# SERVICE NO. 1194B

# BULLETIN

Date: April 12, 2012

**PERIODIC REPLACEMENT OF NOSE BAGGAGE  
DOOR COMPONENTS**

**FIGURE 6**  
**RELOCATION OF 30852-000, IF**  
**REQUIRED TO ACHIEVE CLEARANCE**  
**FROM 28467-003**

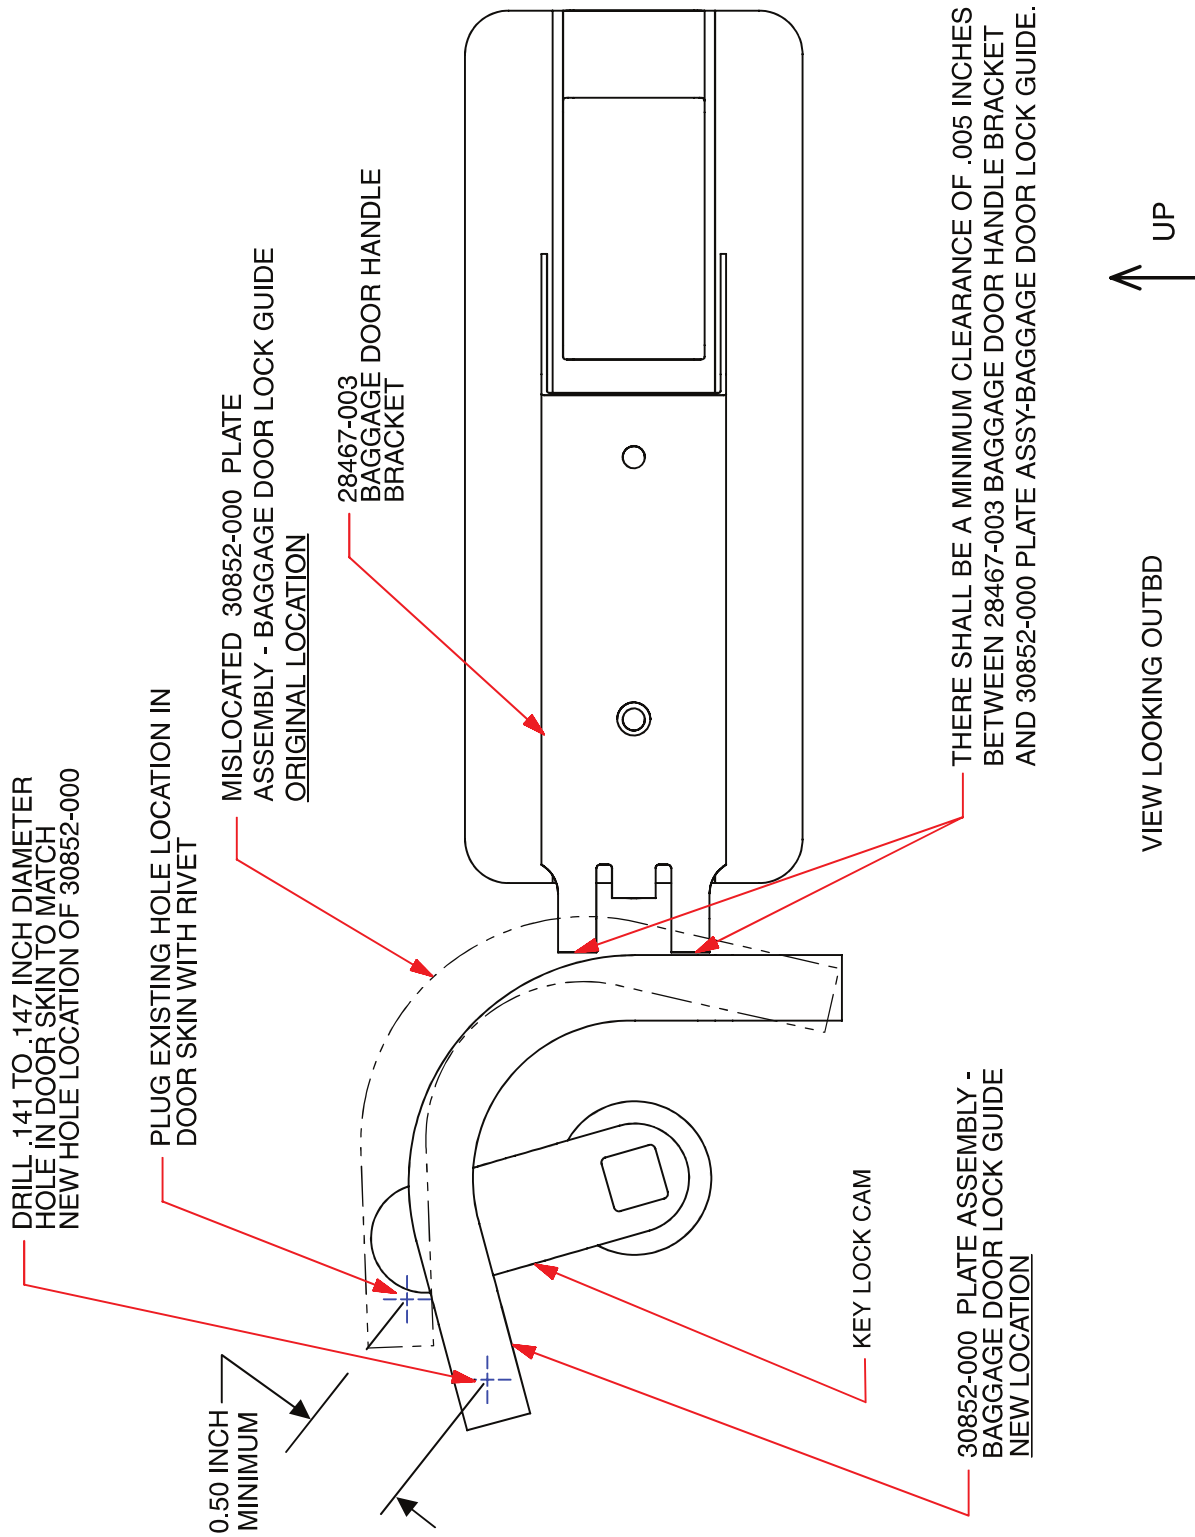
Remove upper screw, and loosen lower screw. Rotate the 30852-000 PLATE ASSEMBLY – BAGGAGE DOOR LOCK GUIDE as needed to achieve clearance, as shown in figure 6. With a positive clearance of at least .005 inches established, verify proper operation of latching and locking mechanism. Mark the door skin with the new location of the upper threaded insert in the 30852-000 PLATE ASSEMBLY – BAGGAGE DOOR LOCK GUIDE. Verify that the spacing between this new proposed fastener location and the original fastener location is at least .50 inches. Drill a .141 to .147 inch diameter hole in the door skin, to match the new location of the upper threaded insert in the 30852-000 PLATE ASSEMBLY – BAGGAGE DOOR LOCK GUIDE. Plug the original open hole with a driven rivet of suitable size, MS20470AD or equivalent, with manufactured head placed on the outboard side of the door. Tighten both screws common to the 30852-000 PLATE ASSEMBLY – BAGGAGE DOOR LOCK GUIDE. If needed, it is permissible to remove .05 inches of material from the 30852-000 PLATE ASSEMBLY – BAGGAGE DOOR LOCK GUIDE to achieve the required operating clearance, provided that the reworked edge is smooth, free of scratches or burrs, blended into adjacent surfaces, and painted with suitable primer.
